DFCM Addendum No.1

Date: July 20, 2023
To: Bidding Contractors
From: Carl Francis-DFCM Project Manager
Reference: Main Campus Meat Lab Freezer Floor Repairs
 DFCM Project 23462210

date: 6/15/2023
project: BTech Meat Services
Freezer Floor Replacement
by: Stephen Williams
subject: Addendum 1

FLOOR PLAN,
 DEMOLITION PLAN &
 DETAILS

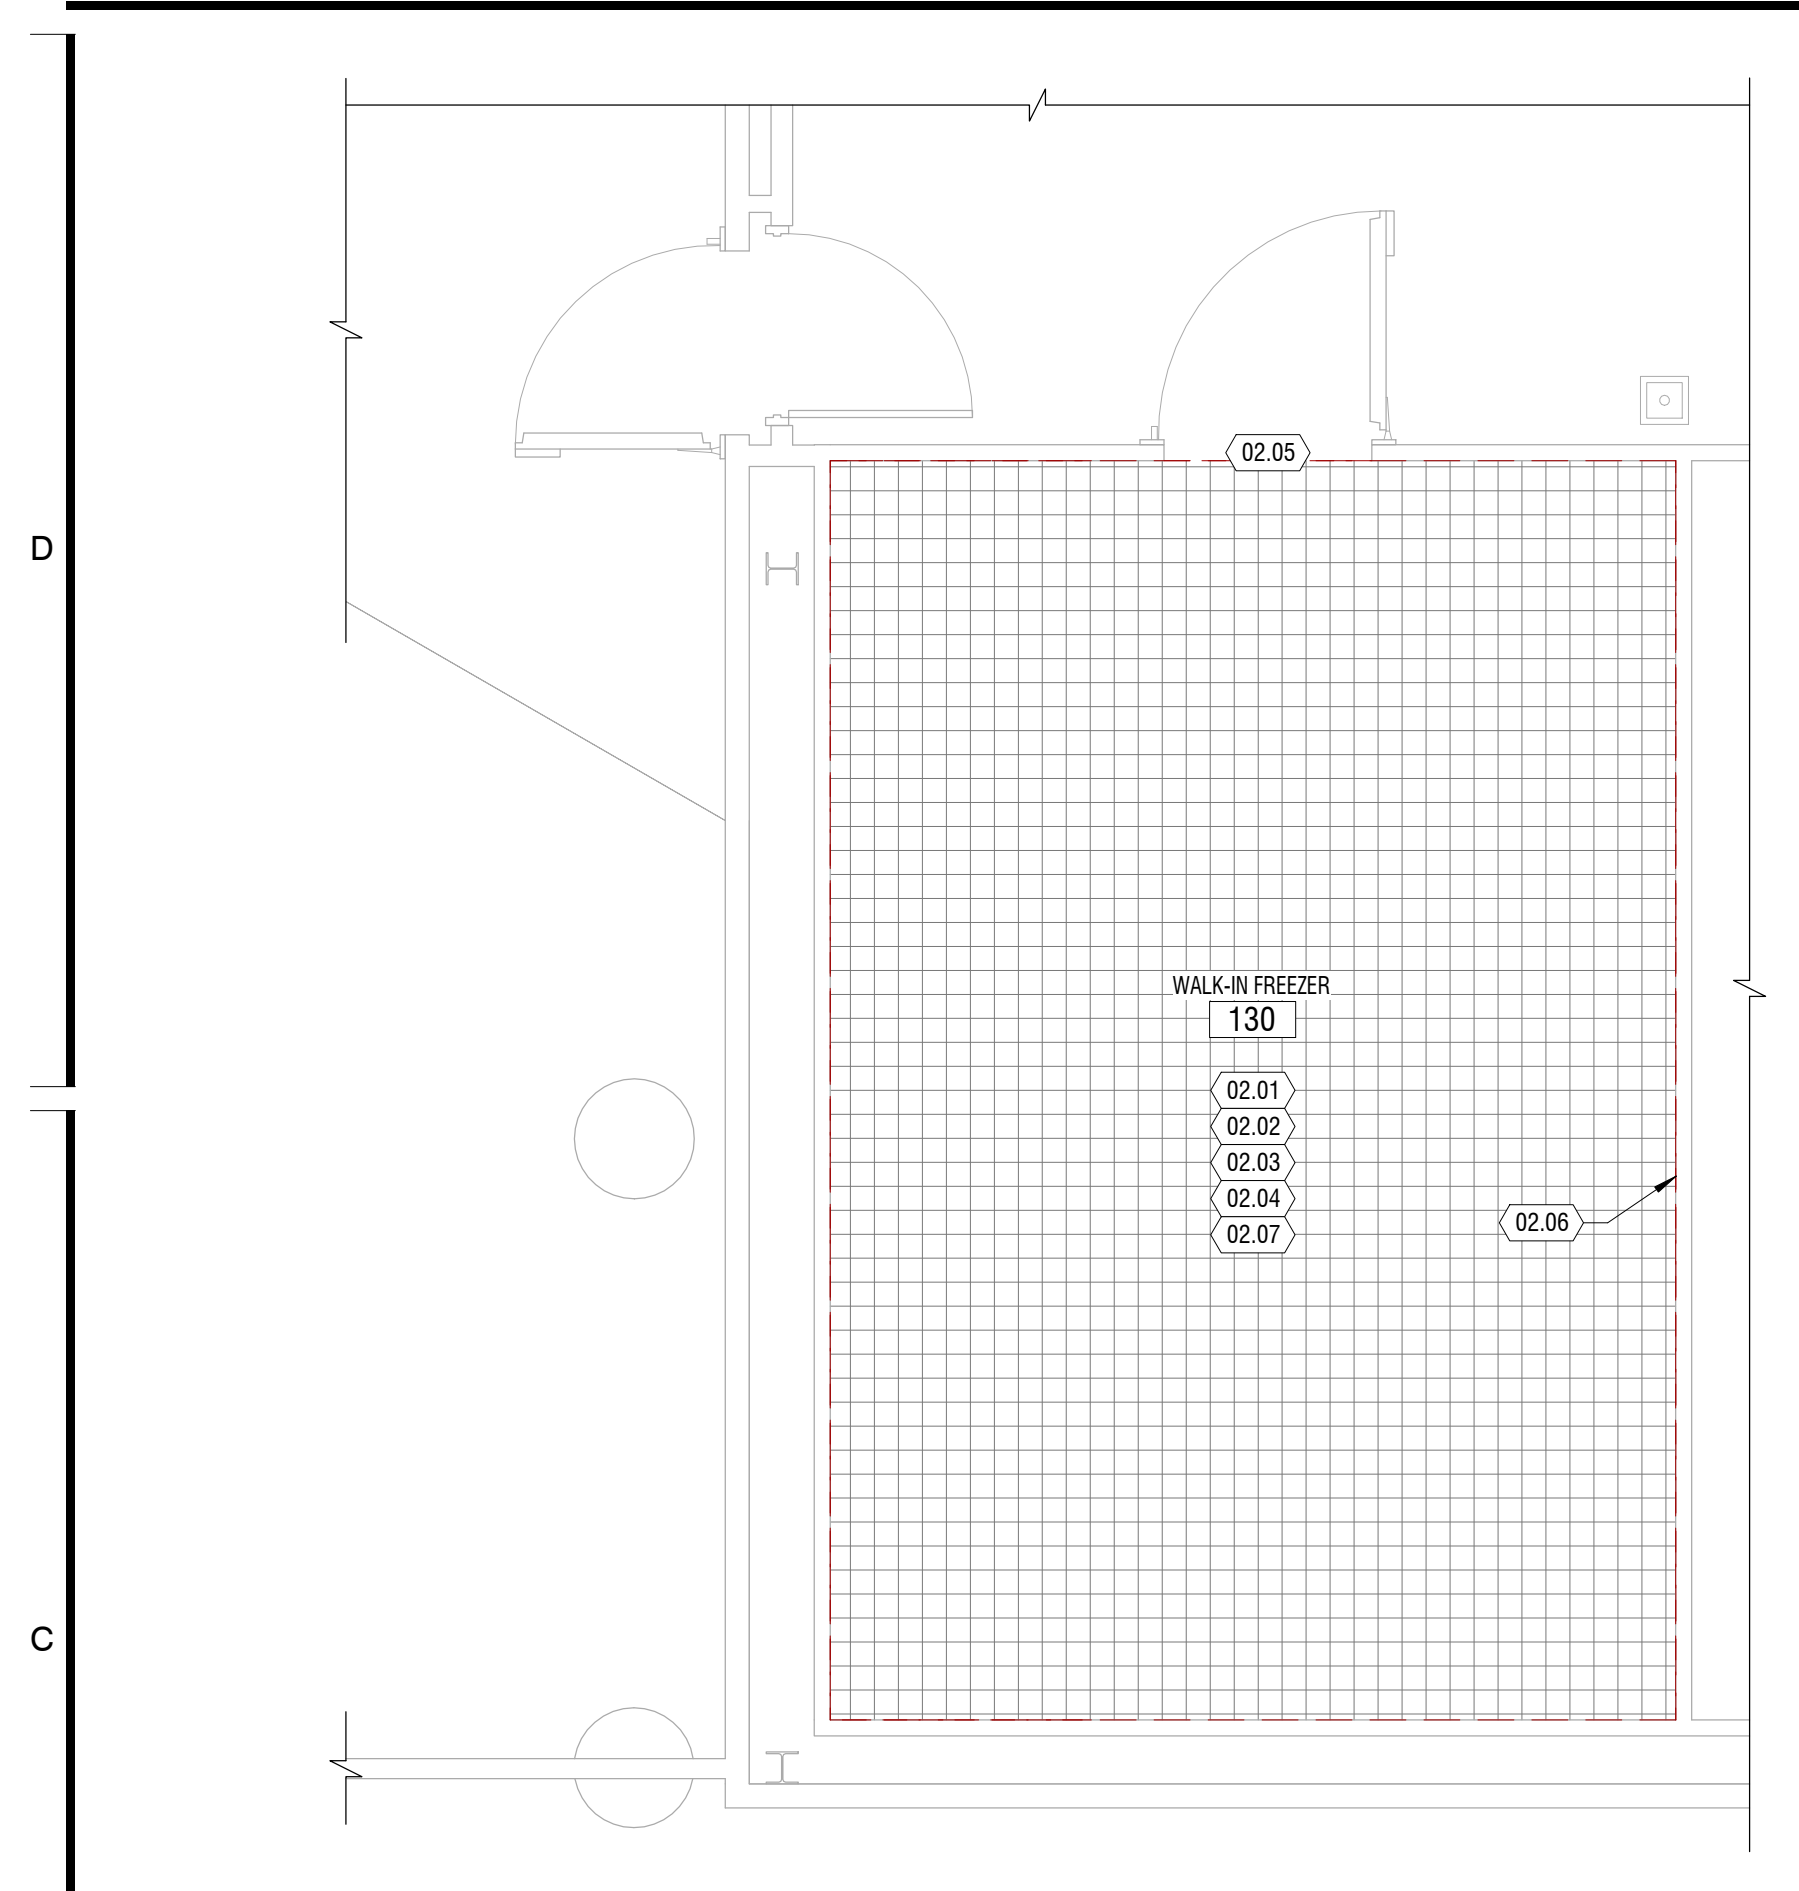
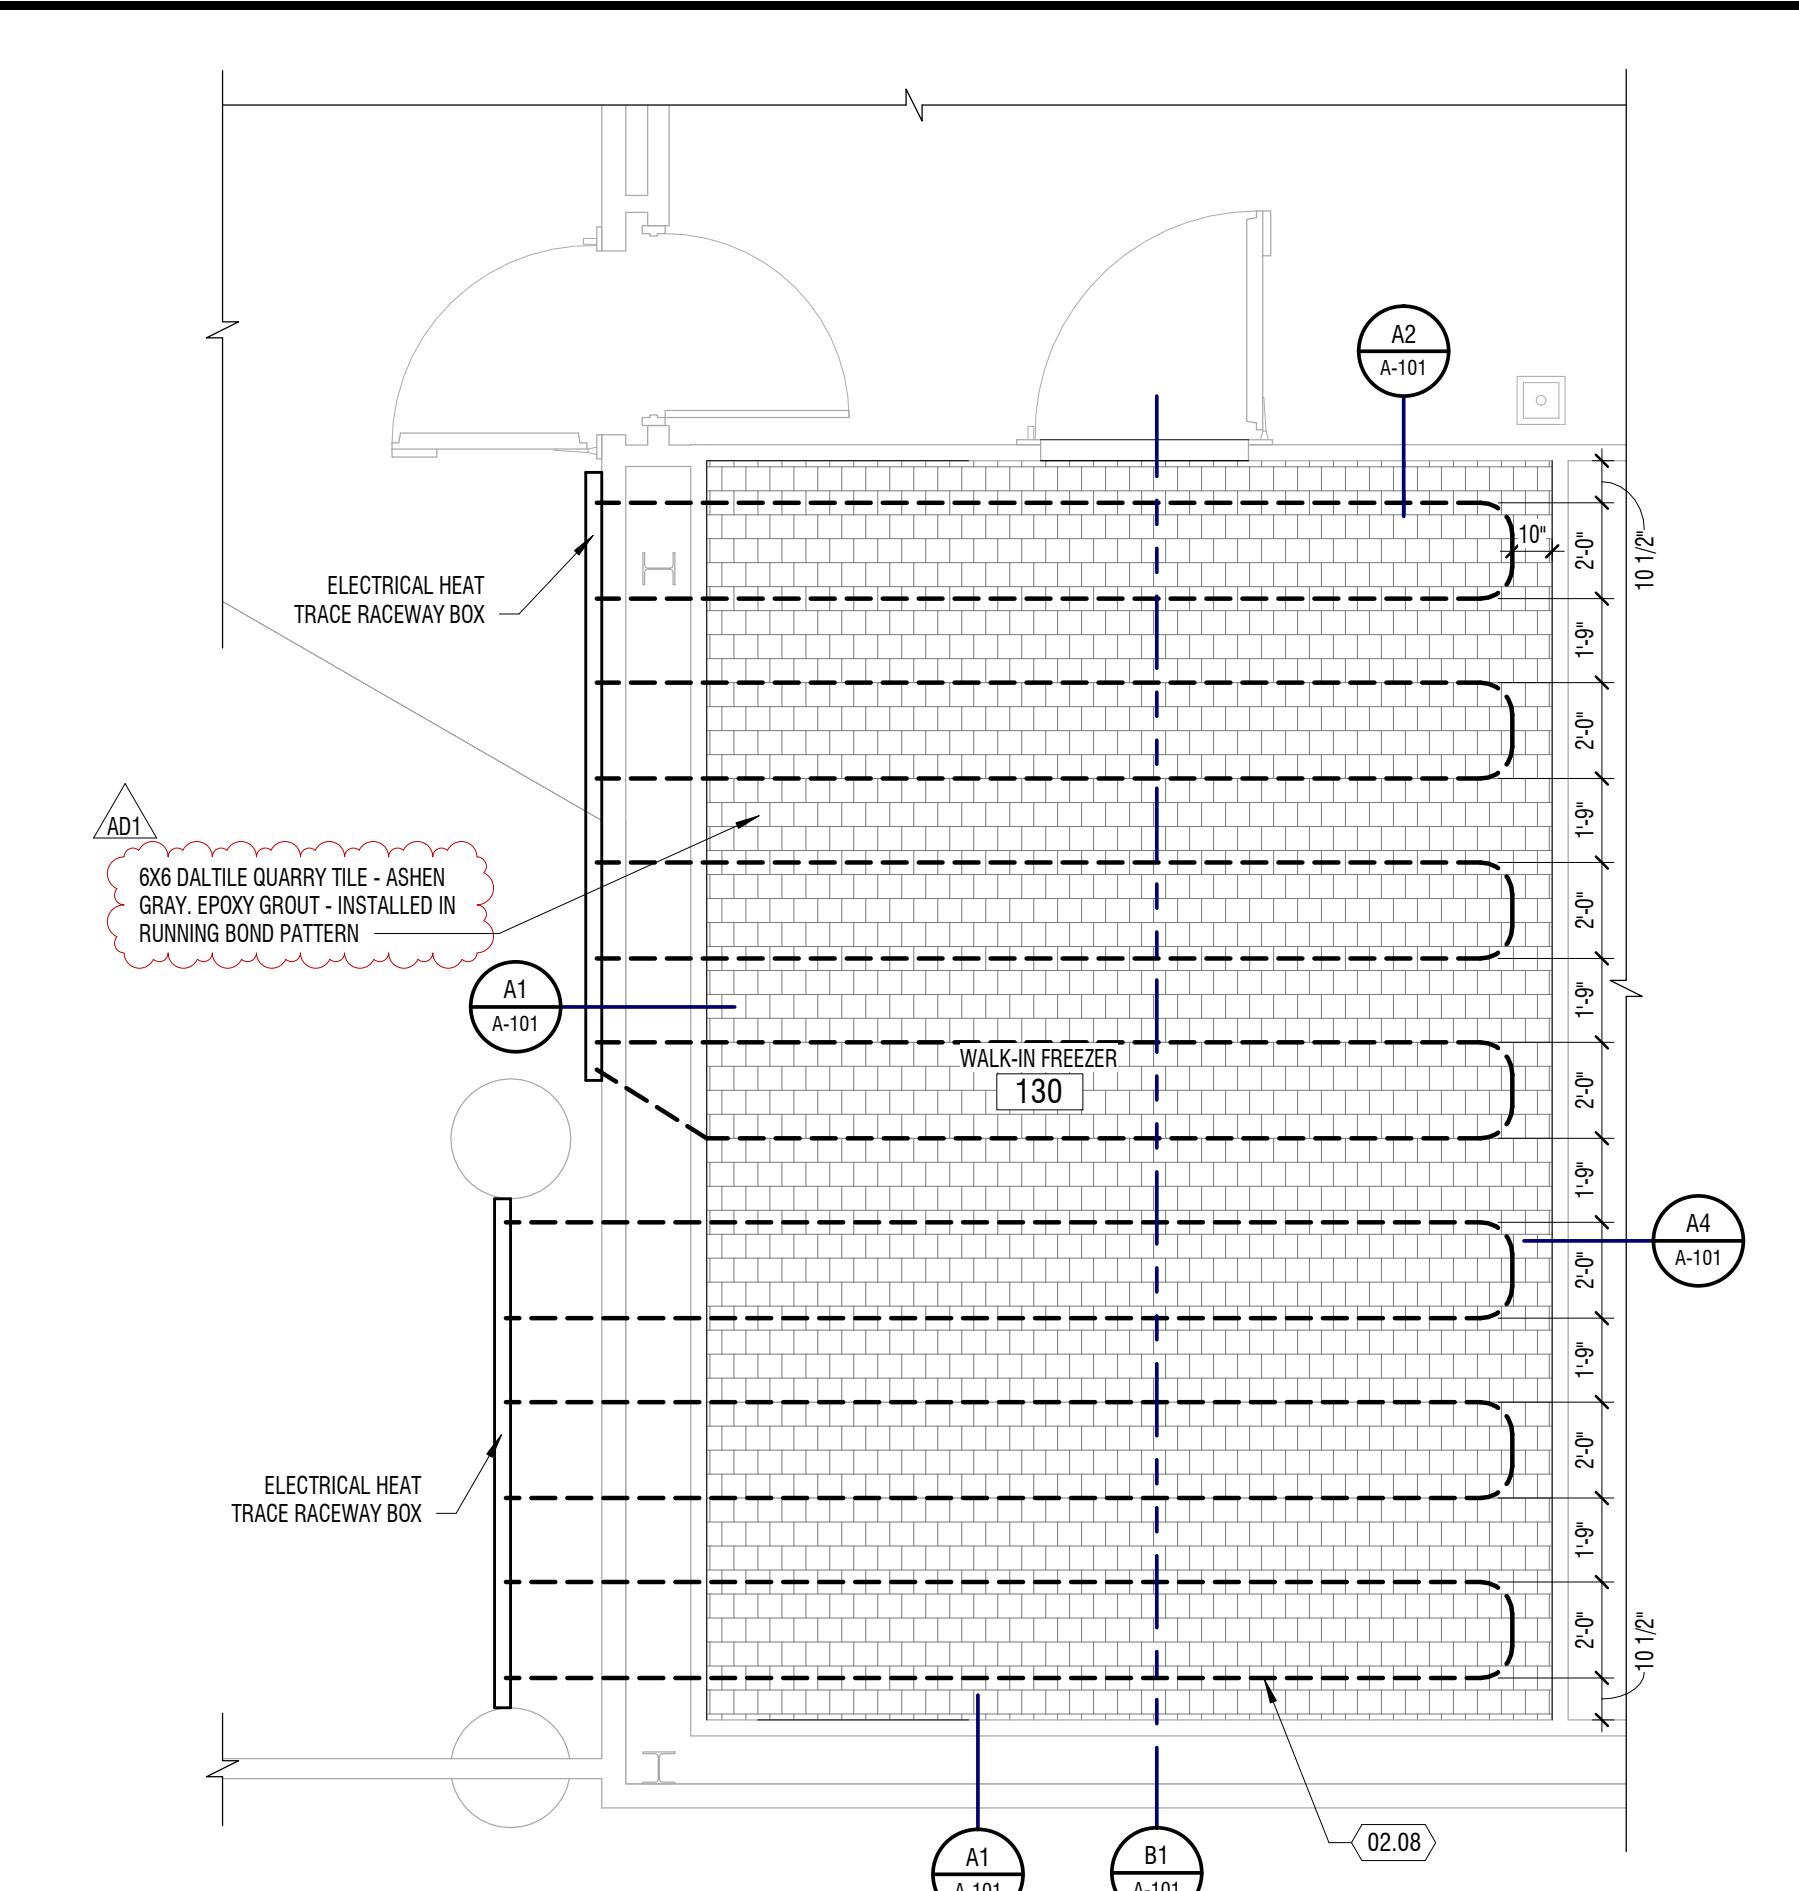
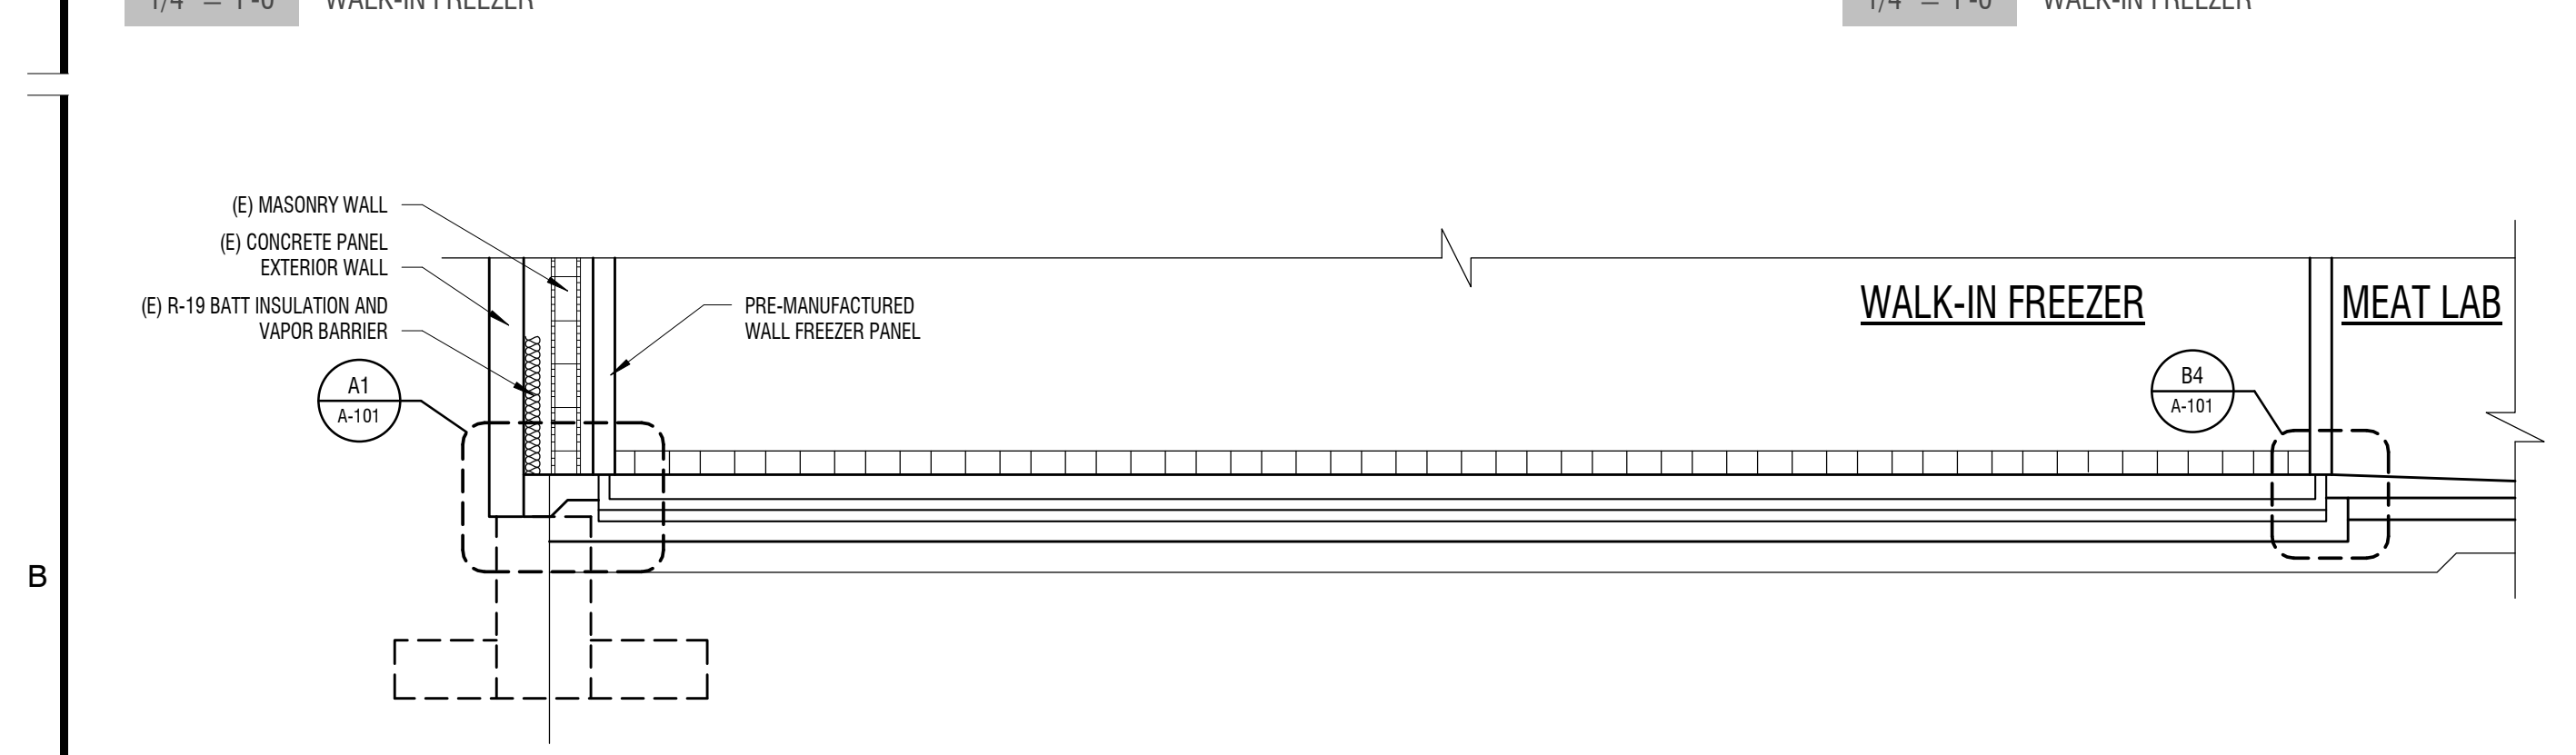
AD1.0.2 A-101 FLOOR PLAN, DEMOLITION PLAN & DETAILS

1. Clarified floor components
 - a. PSI strength for concrete added
 - b. Specified tile to be installed with pattern layout
 - c. Added epoxy grout requirement
 - d. Added Welded Wire Fabric Mesh requirement to notes including size and placement.
 - e. Adjusted conduit sizing to 1" from ¾" to align with electrical requirement.
 - f. Specified MIL thickness of vapor barrier.
